ENGINE—OIL LEAK FROM POSITIVE CRANKCASE VENTILATION (PCV) VALVE AREA—VEHICLES BUILT BEFORE 5/17/2002 EQUIPPED WITH 4.6L 2V ENGINE ONLY

Article No. 02-17-2

FORD: 2002 MUSTANG

Figure 1 - Article 02-17-2

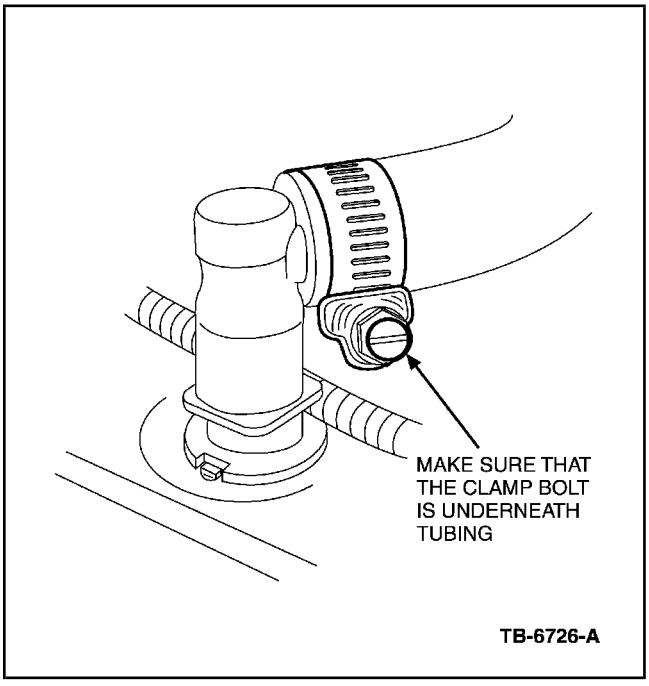
Some vehicles equipped with a 4.6L 2V engine built before May 17, 2002, may exhibit an oil leak coming from the camshaft/valve cover area, where the positive crankcase ventilation (PCV) valve mounts. This leak may be caused by the stack up tolerance between the PCV valve and tube assembly.

Verify condition. To service, install hose clamp onto the PCV tube assembly at the PCV valve. Refer to the following Service Procedure for details.

1. Verify that oil is present on the cam cover area.
2. If oil is present, remove the Air cleaner outlet tube per the Workshop Manual (Section 303-12-3).
3. Disconnect the tube from the PCV valve per the Workshop Manual (Section 303-08-7).
4. Install hose clamp (376240-S100) onto tube assembly, with the worm gear down (Figure 1).
5. Re-install tube assembly onto the PCV valve per the Workshop Manual.
6. Tighten the hose clamp to 12-20 Lb-in (1.3-2.3 N•m).
7. Re-install air cleaner outlet tube per the Workshop Manual.
8. Clean excess oil from the cam cover area.
9. Check to make sure the engine has the proper oil level.
10. Verify repair.
